**Planning Scheme Amendment for 609-621 Burwood Highway, Knoxfield**

Document ID: D18-125728

**CROWN ALLOTMENT 2258  
BURWOOD HIGHWAY AND  
SCORESBY ROAD KNOXFIELD  
COMPREHENSIVE DEVELOPMENT PLAN**

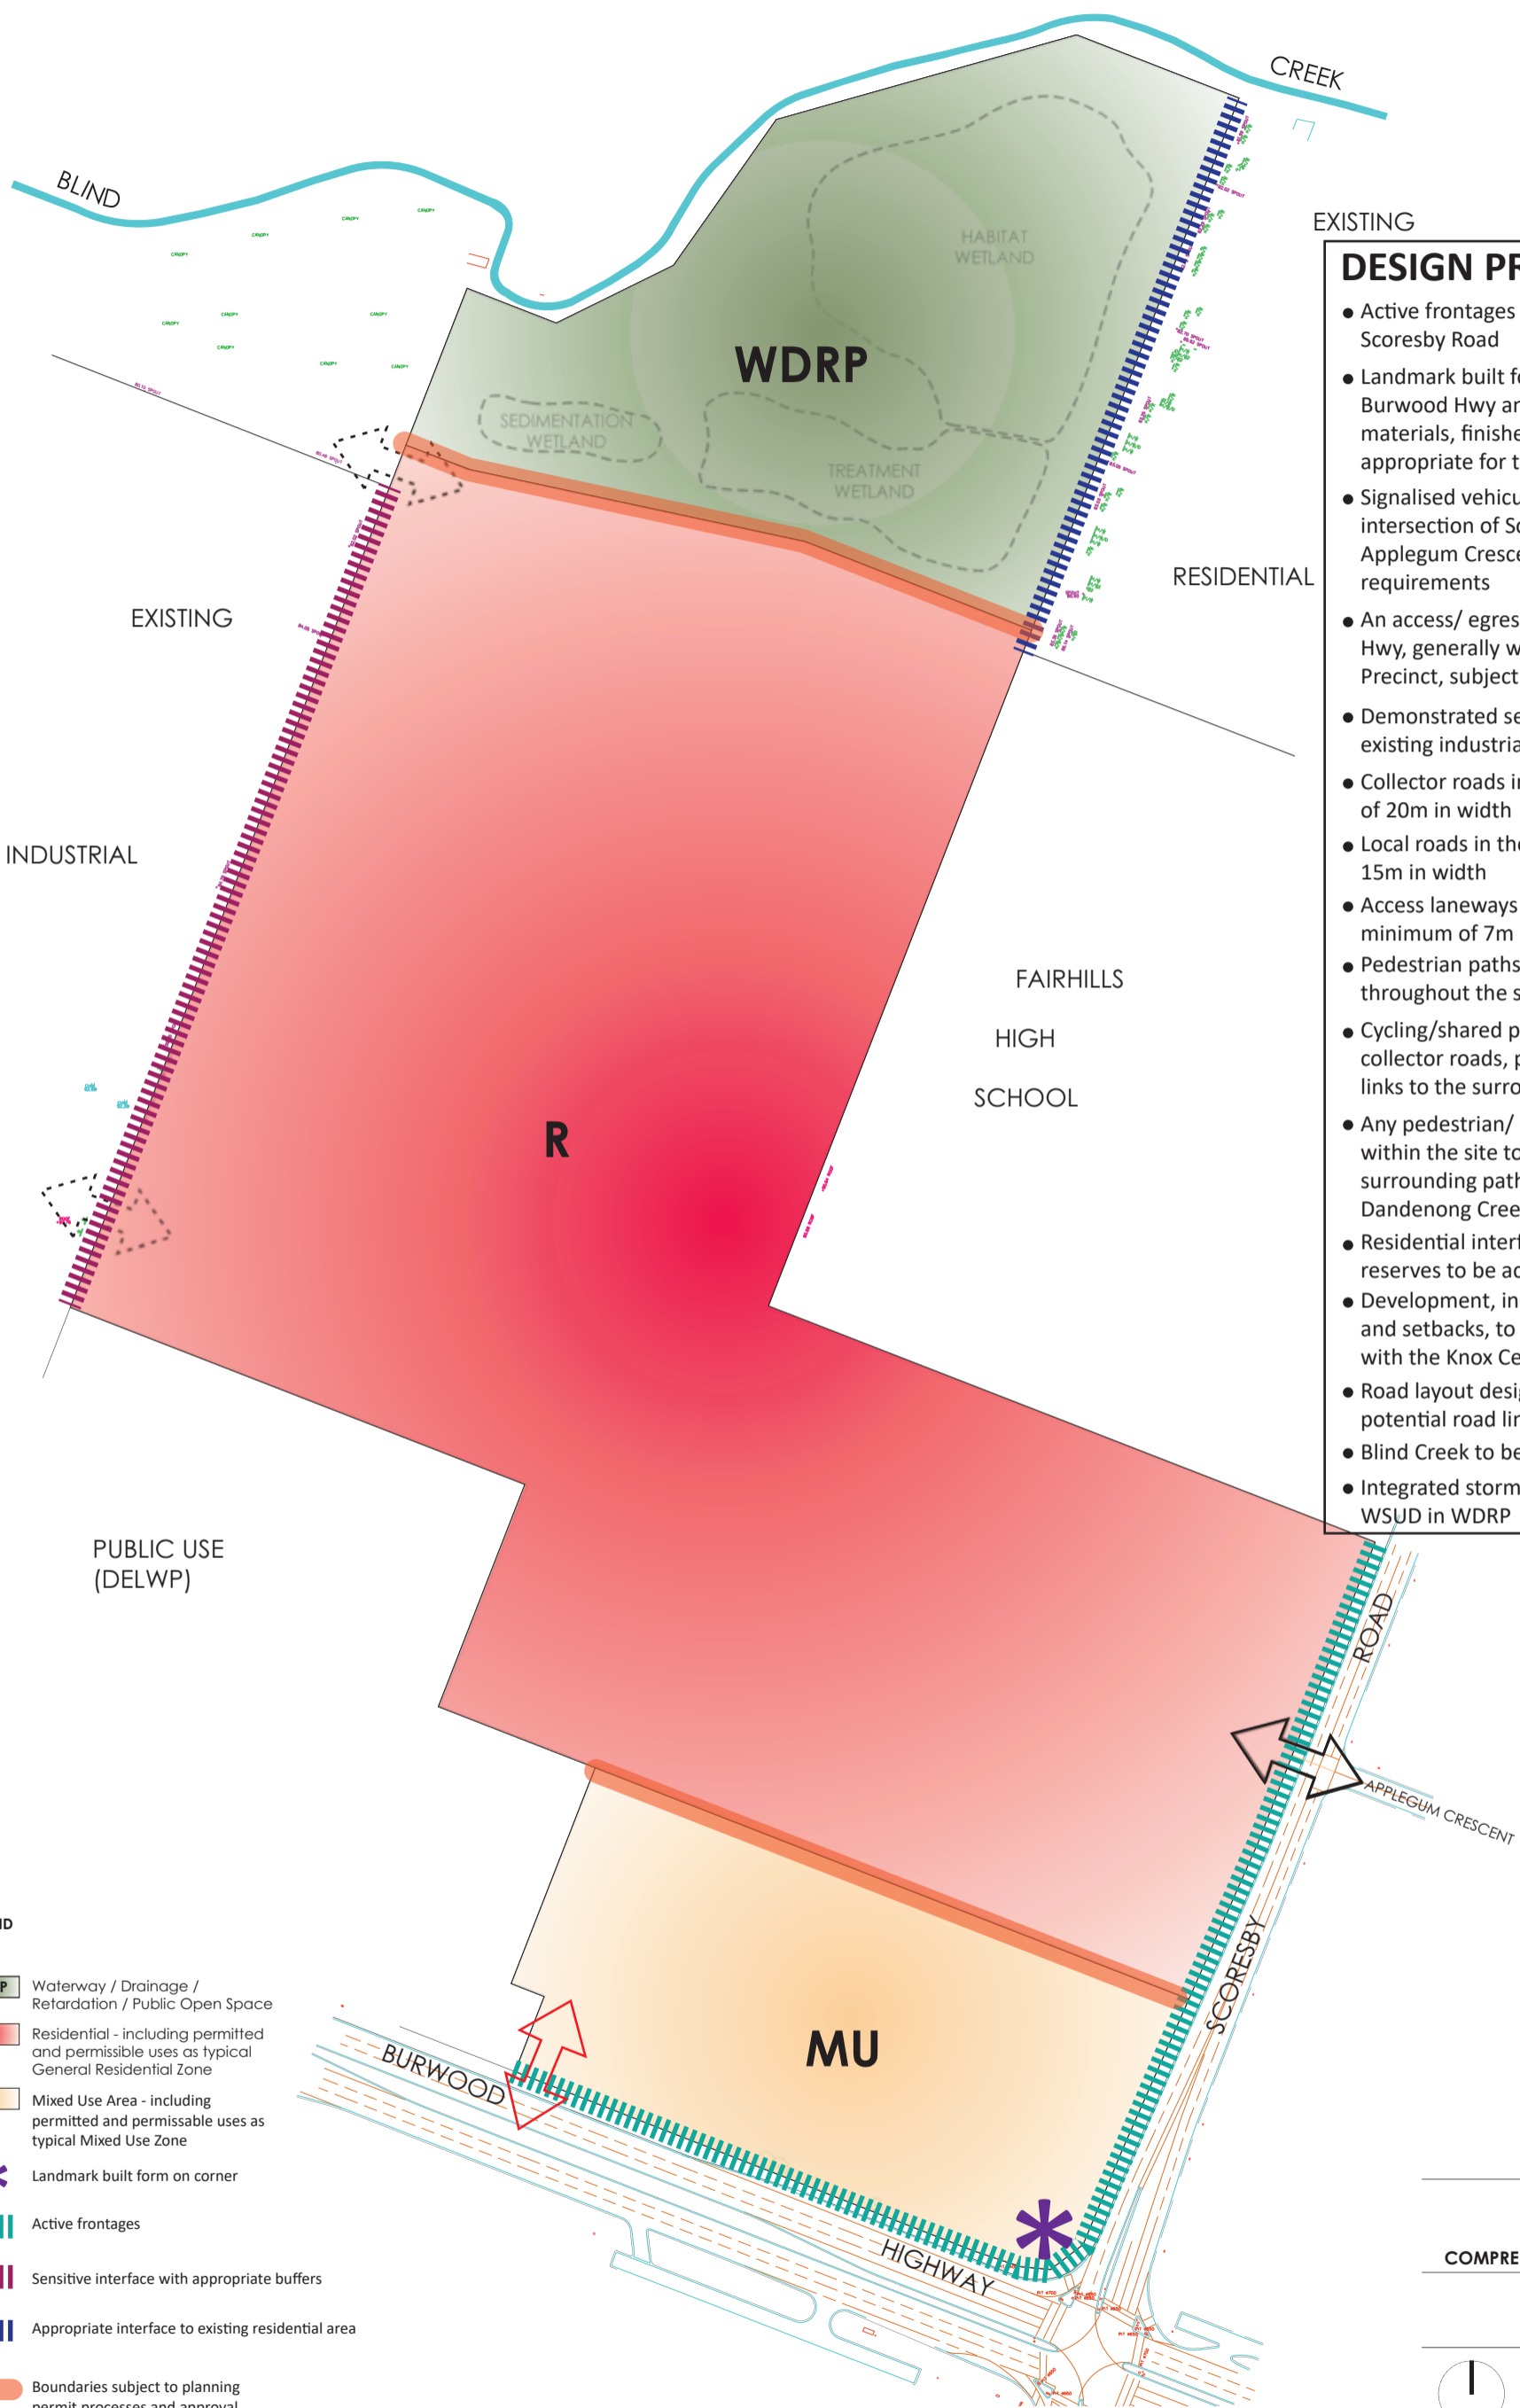
Council officers have discussed the above issues with the exhibited CDZ/CDP documents with the proponent. In light of these discussions, Council has prepared a revised CDP incorporating the above elements and additional design principles which are considered to be the base level of information that must be shown on a CDP incorporated into the planning scheme.

A revised CDP is also included as an attachment to this submission. The proponent has reviewed this revised CDP, and has identified that it supports the inclusion of the following components:

- Mixed Use Area – including permitted and permissible uses as typical Mixed Use Zone;
- Landmark built form on corner;
- Active frontages;
- Boundaries subject to planning permit processes and approval;
- Key vehicular Access/ Egress Point - location along Burwood Hwy subject to VicRoads requirements; and;
- Changing Future Access/ Egress Point' back to Potential Future Access/ Egress Point.

Conversely to this, the proponent and Council have not been able to agree completely of the inclusion of the following components in the revised CDP:

- An access/ egress point along Burwood Hwy, generally west of the Mixed Use Precinct, subject to VicRoads requirements (*Council has moved the indicative location further to the east, within the MUZ precinct on land included in the subject site*);
- Demonstrated sensitive interface with the existing industrial area to the west (*Council's preference is for interface treatments and does not agree to modify this requirement until acoustic and air quality reports are reviewed*);
- Local roads in the site to be a minimum of 15m in width including along park frontages, rather than 13.5m as suggested, (*Council requires the inclusion of trees within the road reserve*);
- Development, including building heights and setbacks, to be generally in accordance with the Knox Central Structure Plan, 2017;

- *Sensitive interface with appropriate buffers;*
- *Appropriate interface to existing residential area; and;*
- *Future Access/ Egress Point*

- Development, including building heights and setbacks, to be generally in accordance with the Knox Central Structure Plan, 2017
- Road layout design to accommodate future potential road linkages to the west

- WDRP** Waterway / Drainage / Retardation / Public Open Space
- R** Residential - including permitted and permissible uses as typical General Residential Zone
- MU** Mixed Use Area - including permitted and permissible uses as typical Mixed Use Zone
- \*** Landmark built form on corner
- ||||** Active frontages
- ||||** Sensitive interface with appropriate buffers
- ||||** Appropriate interface to existing residential area
- Boundaries subject to planning permit processes and approval
- ↔** Key vehicular Access/ Egress Point - location along Burwood Hwy subject to VicRoads requirements
- ↔** Key Vehicular Access / Egress Point
- ⋯** Possible Future Access / Egress Point
